Planning Sub-Committee B

Monday 6 December 2021

Item No: 7.1 and 7.2	Classification: Open	Date: 6 December 2021	Meeting Name: Planning Sub-Committee B
Report title:		Addendum report Late observations and further information	
Ward(s) or groups affected:		Peckham Rye and	
From:		Director of Planning and Growth

Item 7.1: 21AP0628 & 21AP0629 - The Brunel Museum, Railway Avenue, London, SE16 4LF

Revised site map

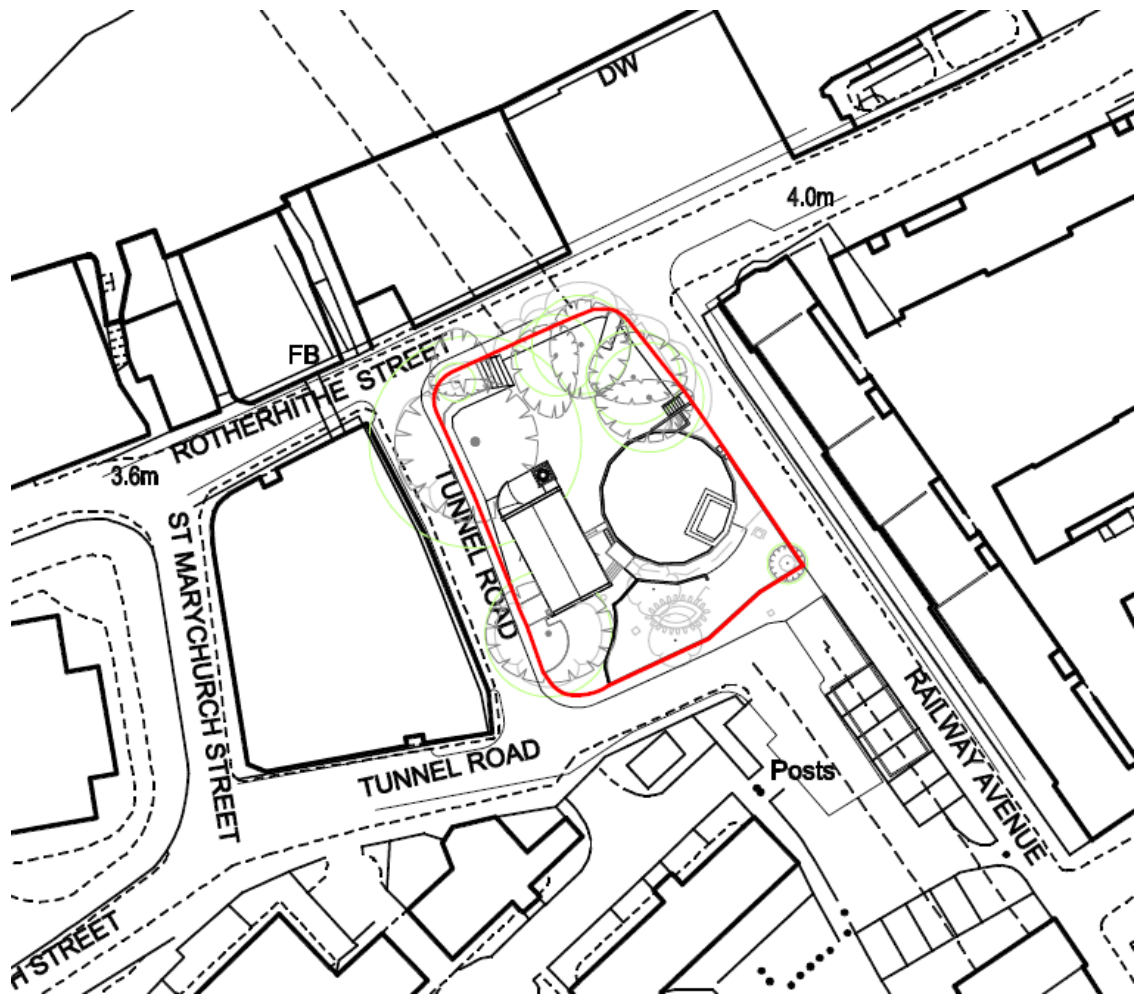
4. The map attached to the Officers' report identifying the site does not include the full extent of the site. The full extent of the site was shown in the applications' site plans, is illustrated within the body of the Officers' report (see paragraph 9) and is as below:
